PL-1 NEWSLETTER No. 5

ENGINEERING CHANGE NOTICE # 5

SHEET # 2
JAN. 1967

DWG 1-20.002

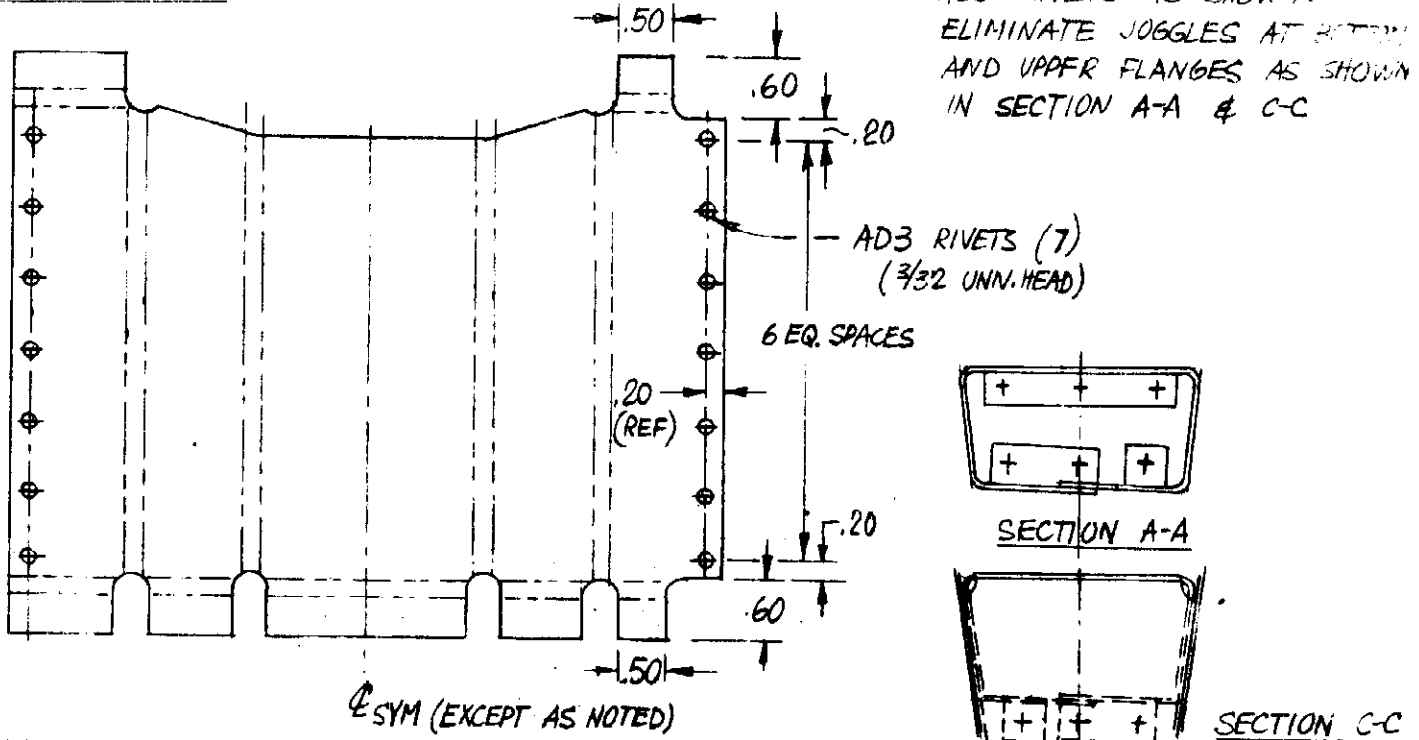
ADD RIVETS AS SHOWN.
ELIMINATE JOGGLES AT BOTTOM
AND UPPER FLANGES AS SHOWN
IN SECTION A-A & C-C

DWG 1-20.001

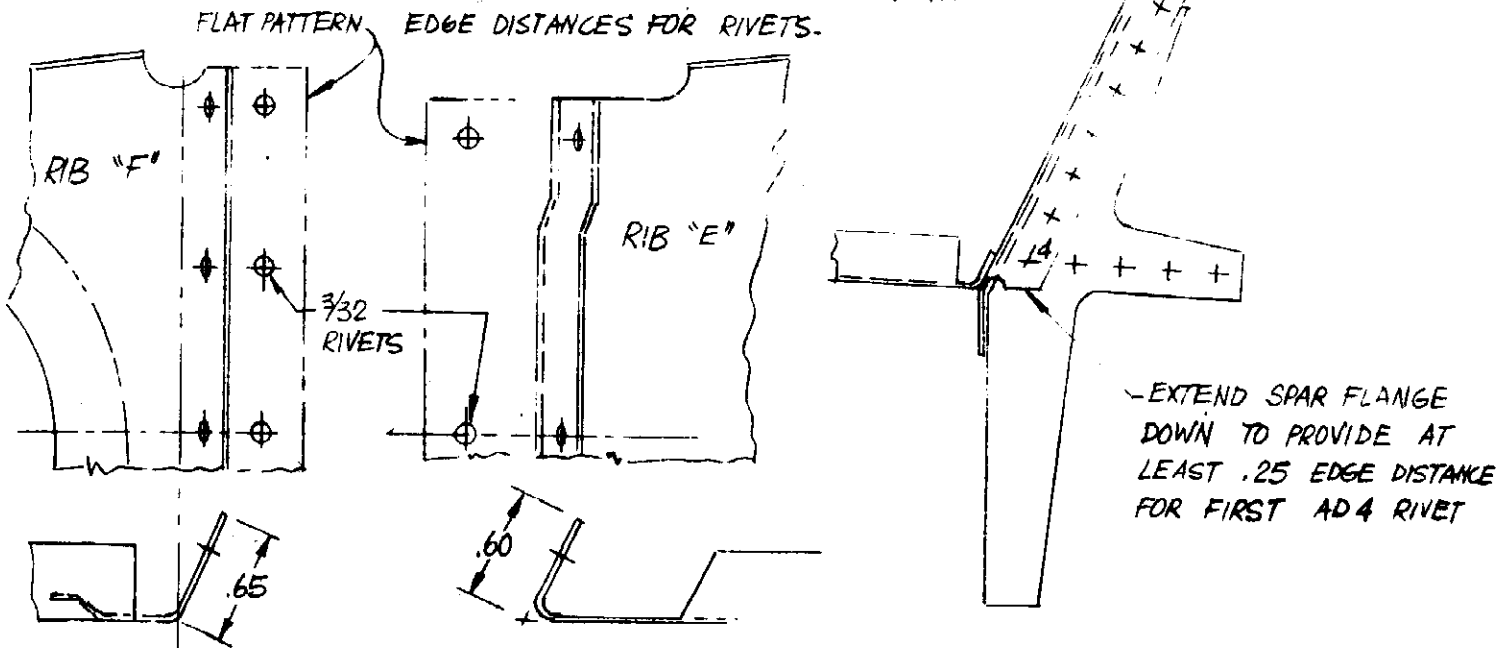
MODIFY RIB "F" & "E" FRONT SPAR ATTACHMENT
FLANGES AS SHOWN TO PROVIDE ADEQUATE
EDGE DISTANCES FOR RIVETS.

DWG -1-30.006

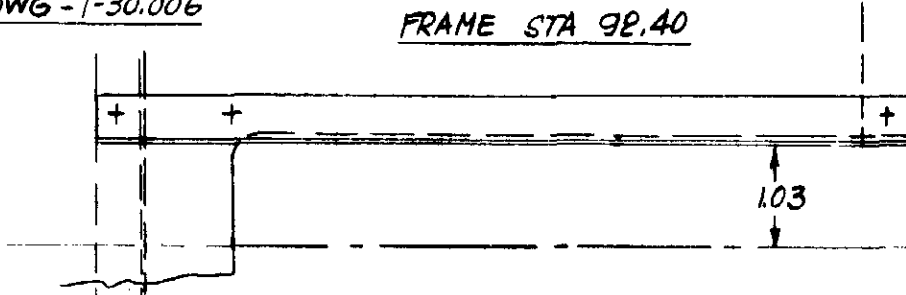
FRAME STA 92.40

CHANGE LOCATION OF ANGLE FOR ATTACHMENT OF FLAP BOX AS SHOWN. (DIMENSION WAS 1.00).

DWG 1-50.006

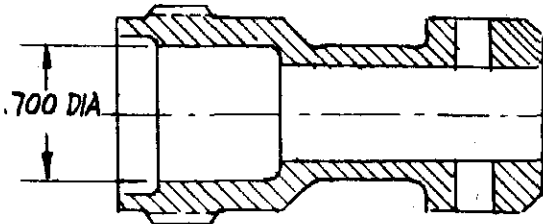
TRIM INDICATOR WORM (STEEL) AND TRIM INDICATOR (NYLON). THREAD PITCH SHOWN IS .400. CHANGE TO .166 (6 THREADS/INCH).

AD DIMENSION TO "HOUSING"

DWG 1-30.008

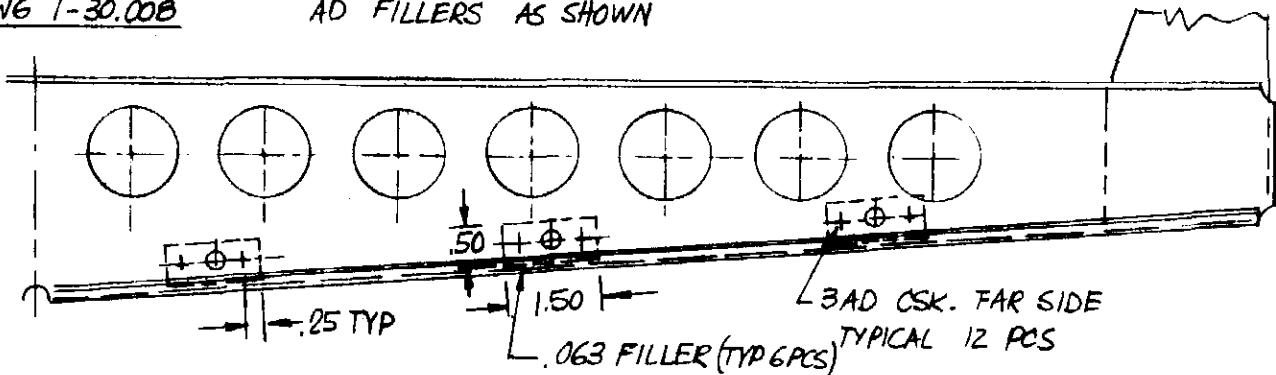
AD FILLERS AS SHOWN

DWG 1-10.008

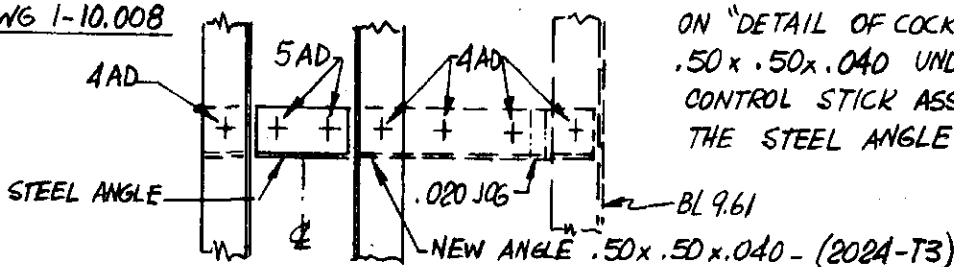
ON "DETAIL OF COCKPIT FLOOR" - SCALE 1/2 AD AN ANGLE .50x.50x.040 UNDERNEAT THE STEEL ANGLE PART OF CONTROL STICK ASSY. USE 5/32 RIVETS TO ATTACH THE STEEL ANGLE

DWG 1-50.002

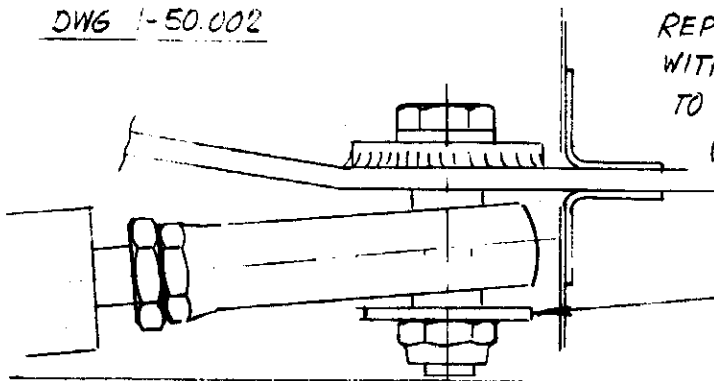
REPLACE THE AN 960-C416 WASHER UNDER THE NUT WITH A AN 970-4 WASHER. THIS IS A SAFETY MEASURE TO AVOID LOOSING CONTROL IF ROD END BEARING FAILS (SEE DESIGNEE BULLETIN #10-EAA-SPORTA/AT-21 SEP 30-1966).

AN 970-3 WASHER. INCREASE HOLE DIA TO .250

DWG 1-10.008

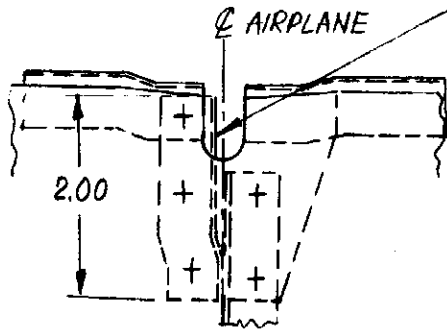
ON "DETAIL OF COCKPIT FLOOR" - SCALE 1/2:

EXTENDED .60x .60x .032 ANGLE AS SHOWN IN DWG 1-10.006

1-40.002

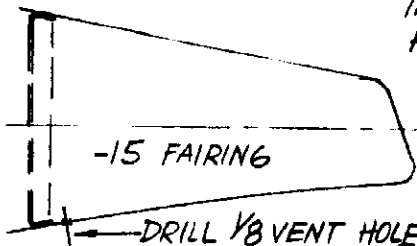
DRILL 1/8 VENT HOLES IN FUEL TANK AFT FAIRING. THIS IS REQUIRED TO AVOID DEFORMATION DUE TO CHANGE IN TEMPERATURE OR ALTITUDE
